Subject: Replacement System; Variance to the Maine Subsurface Wastewater Disposal Rules, Tefft property, Lot #22, Peaks Island, Portland

## Replacement System Variance Request

APPLICATION FOR SUBSURFACE WASTEWATER DISPOSAL PERMIT

Subsurface Wastewater Disposal Area Cross-section  
Scale: Vertical: 1" = 5'  
Horizontal: 1" = 20'

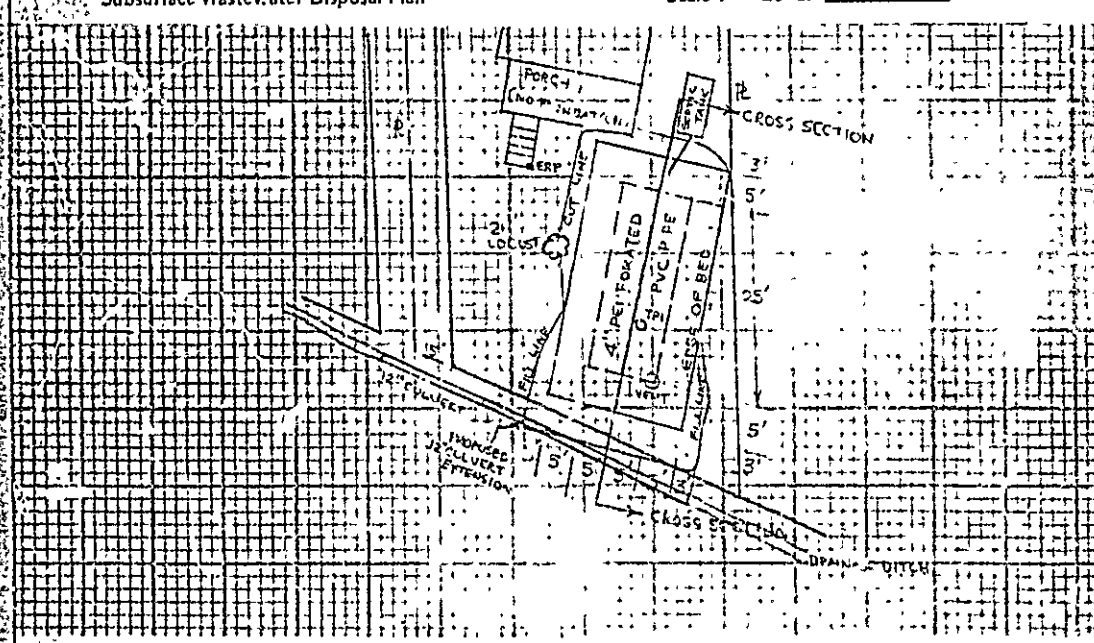
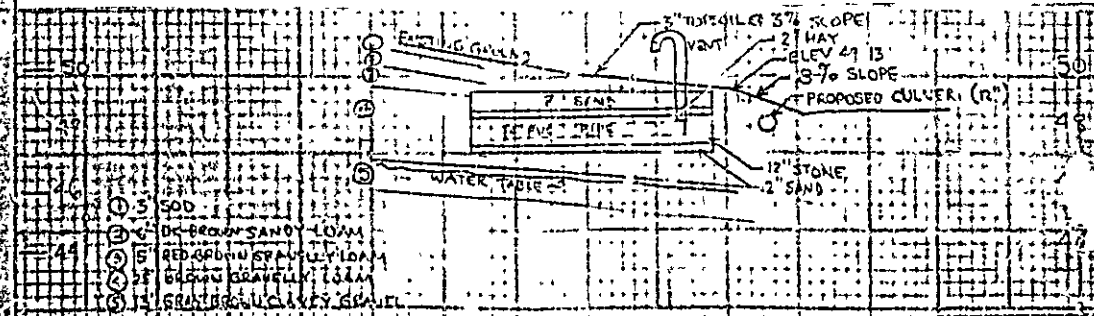
1. Distance from disposal area to man-made drainage ditch from 25 feet to 5 feet;
2. Distance from disposal area to building with basement from 20 feet to 9 feet;
3. Distance from disposal area to property line from 10 feet to 2 feet.

The installation of a 20'x35' bed system to receive the effluent from an existing 750 gallon septic tank.

At least 14 (cut) inches and 7 inches of fill shall be applied on the uphill and downhill sides of the disposal field, respectively. The fill shall be of a texture similar to the original soil and will provide a 12 inch separation between the bottom of the disposal bed and the seasonal high water table and impervious layer. The fill must be extended in all directions as required by Section 11.D of the Subsurface Wastewater Disposal Rules.
